November 7, 1989

Subject: Request for Additional Information
NPDES Permit Renewal for
Catawba Nuclear Station (SC0004278)
File: CN-702.13

Catawba Nuclear Station
Response to DHEC Request for Additional Information
NPDES Permit SC0004278 Reissuance

TEMPERATURE VS. TIME & THERMAL LIMITS

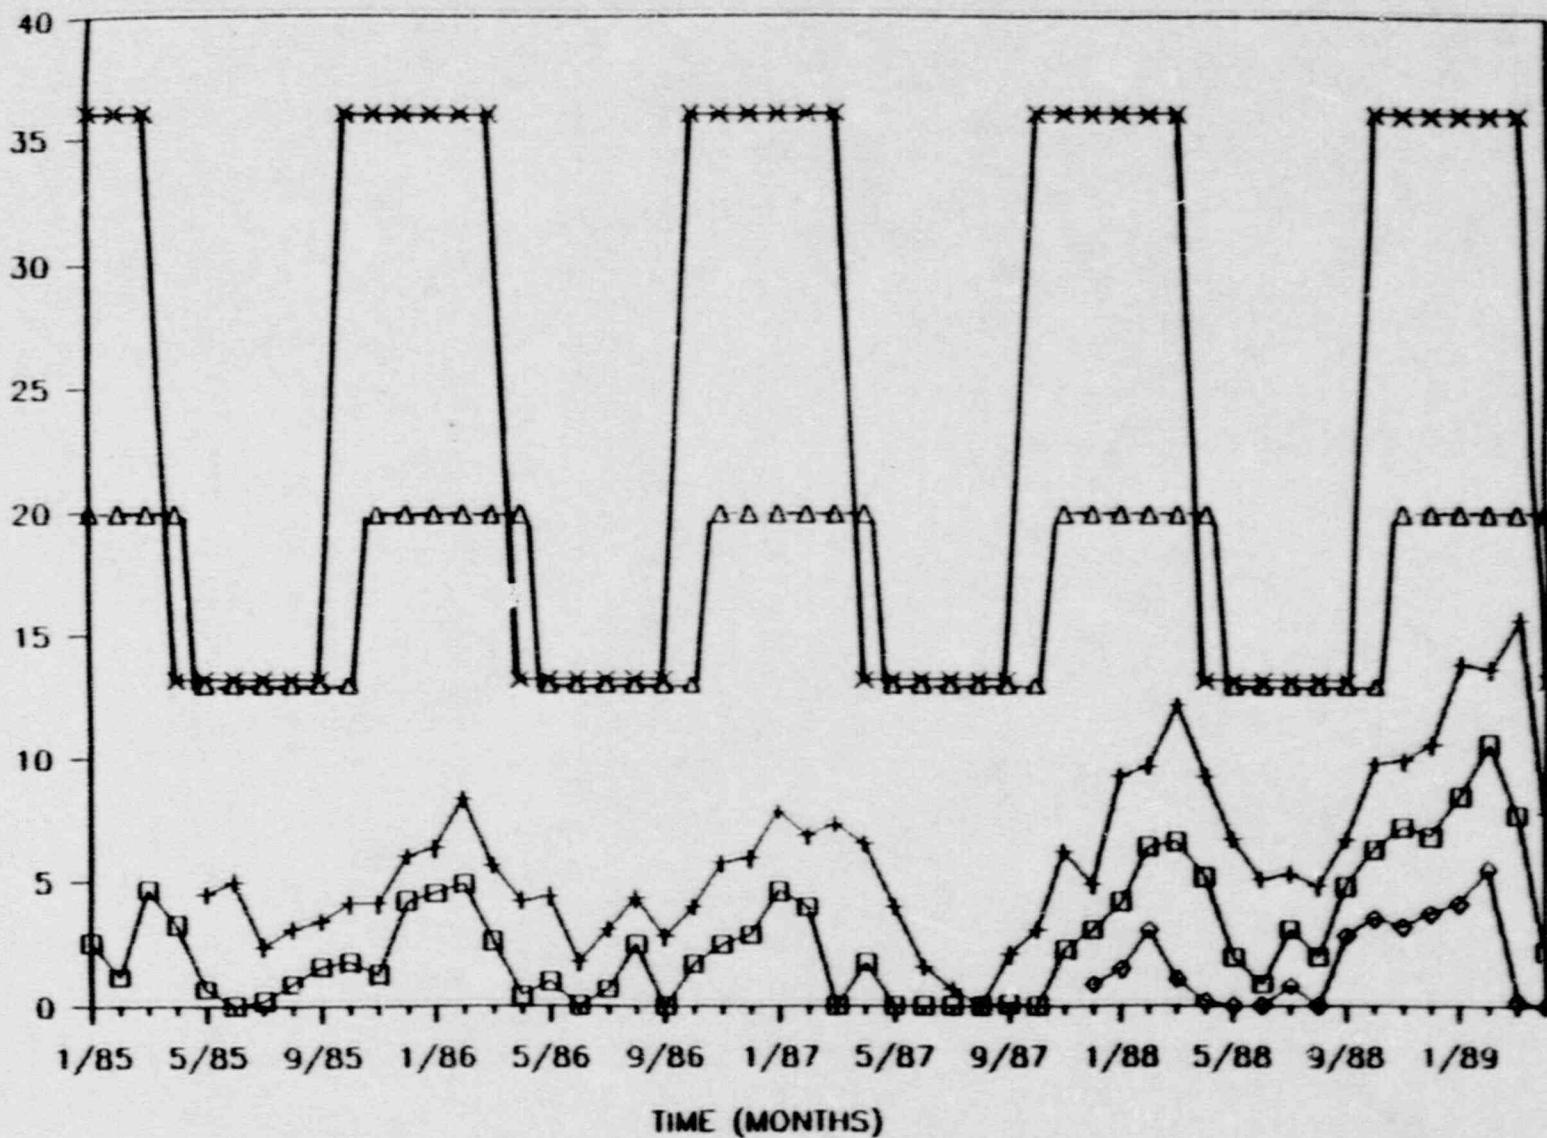
Your agency suggested a reduction of the present differential thermal limits (a monthly average water temperature rise above ambient of 13.2° F from April through September and 36.1° F from October through March), because of the large difference between the current thermal limits and the temperature CNS has actually produced. Based on past and anticipated operation of CNS we concur that the differential thermal limits can be reduced for Outfall 001 and propose the following limits (Attachment 1):

A monthly average water temperature rise above ambient of 13.0° F from May through October and 20.0° F from November through April (ambient water temperature measured at the CNS intake and discharge water temperature measured at Outfall 001).

The maximum (plus), minimum (diamond), and average (square) monthly water temperature rise above ambient, Delta T (°F), from January 1985 through January 1989 at Catawba Nuclear Station Outfall 001. X = current and Δ = proposed differential thermal limits.
